PD Modification Application: MM 24-1152

Hillsborough
County Florida

Development Services Department

1.0 APPLICATION SUMMARY

FIGURE 1

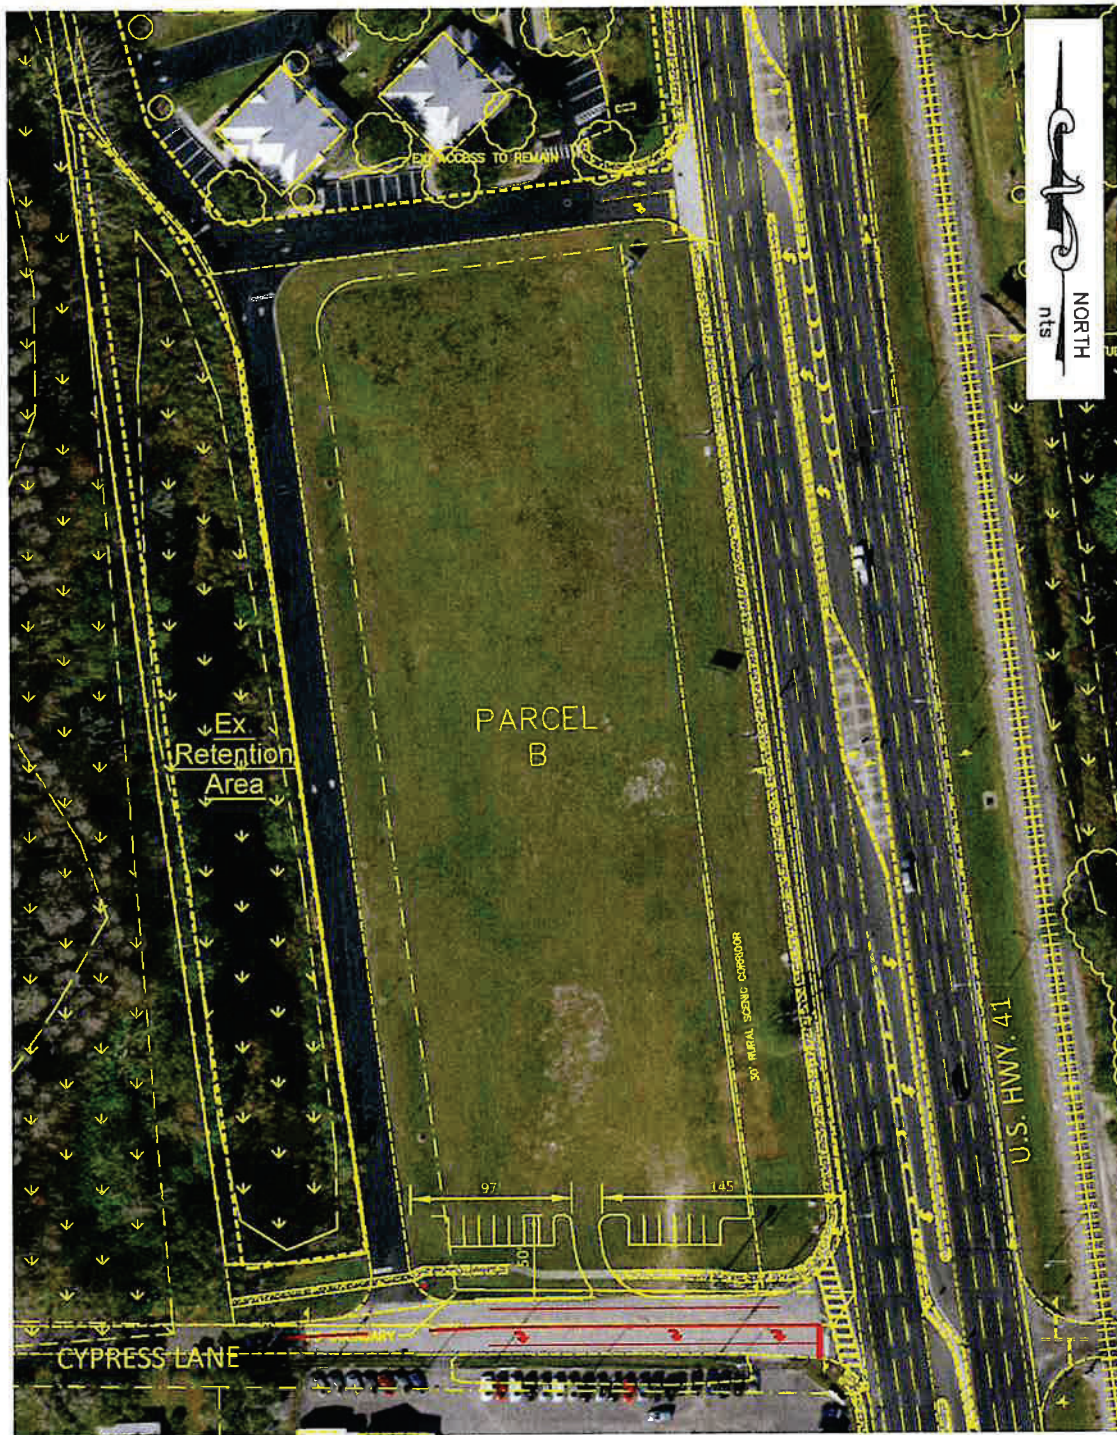
1. The developer proposed to add the following improvements to Cypress Lane:
 - a. Restripe Cypress Lane from US 41 to the western access to provide 11 foot lanes and 6 foot bike lanes.
 - b. Provide 5 foot sidewalk on the north side of Cypress Lane.

Figure 1 illustrates the proposed improvements and Figure 2 illustrates the proposed typical section.

FIGURE 1

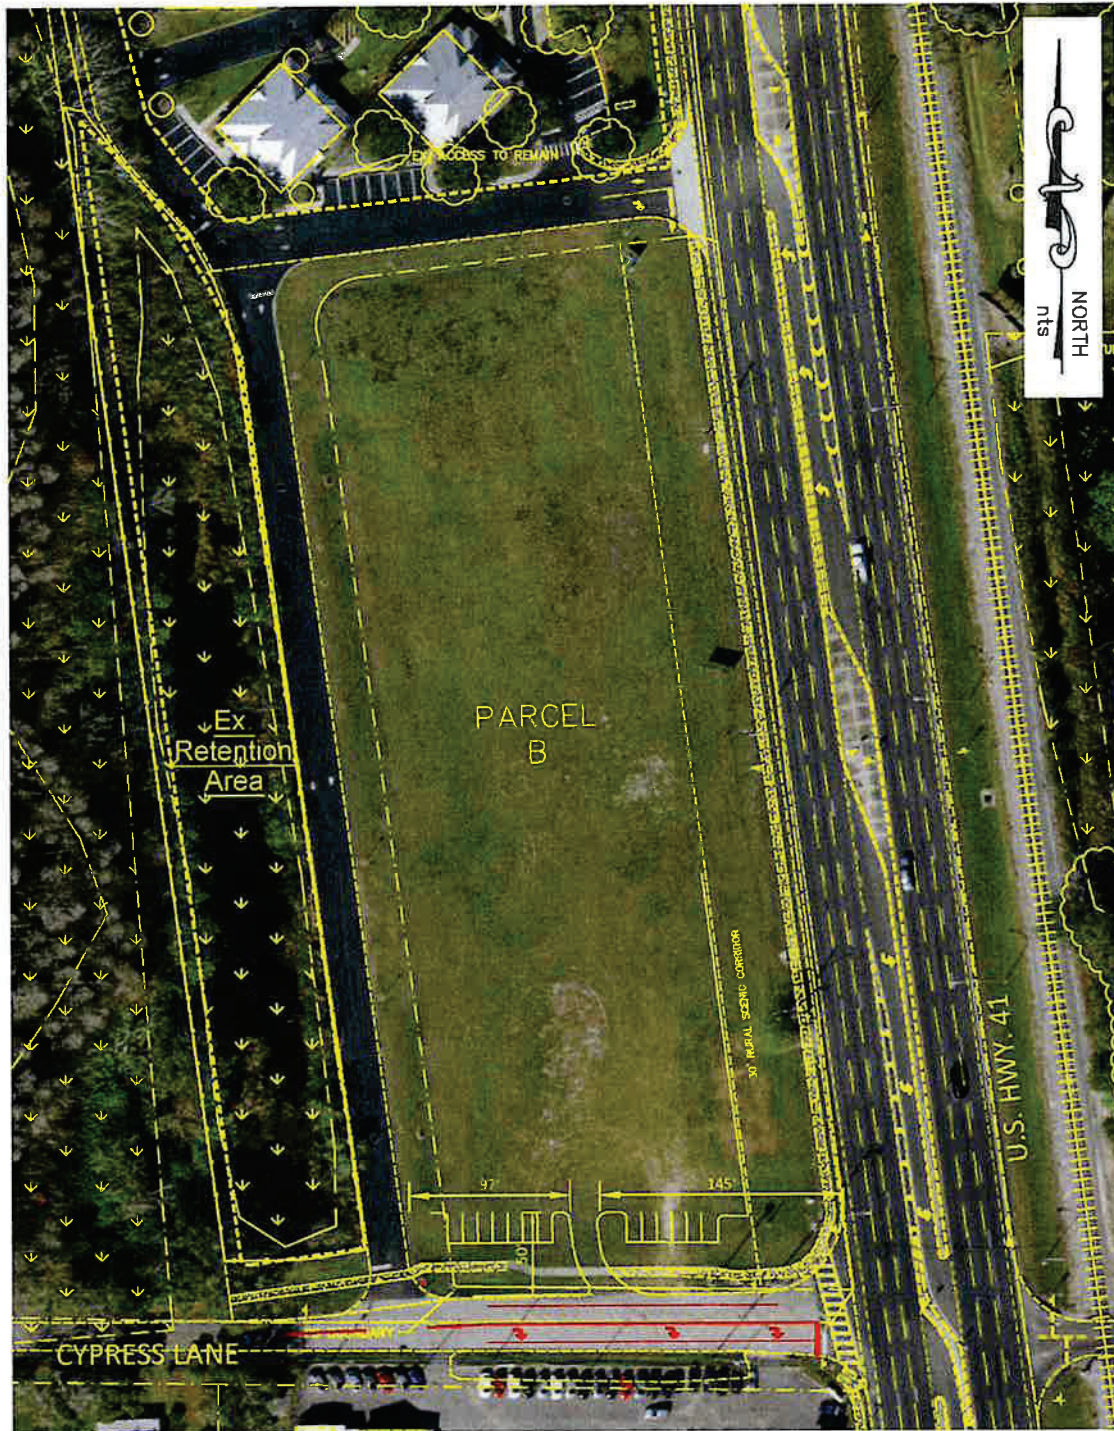
This is graphically shown in Figure 1.
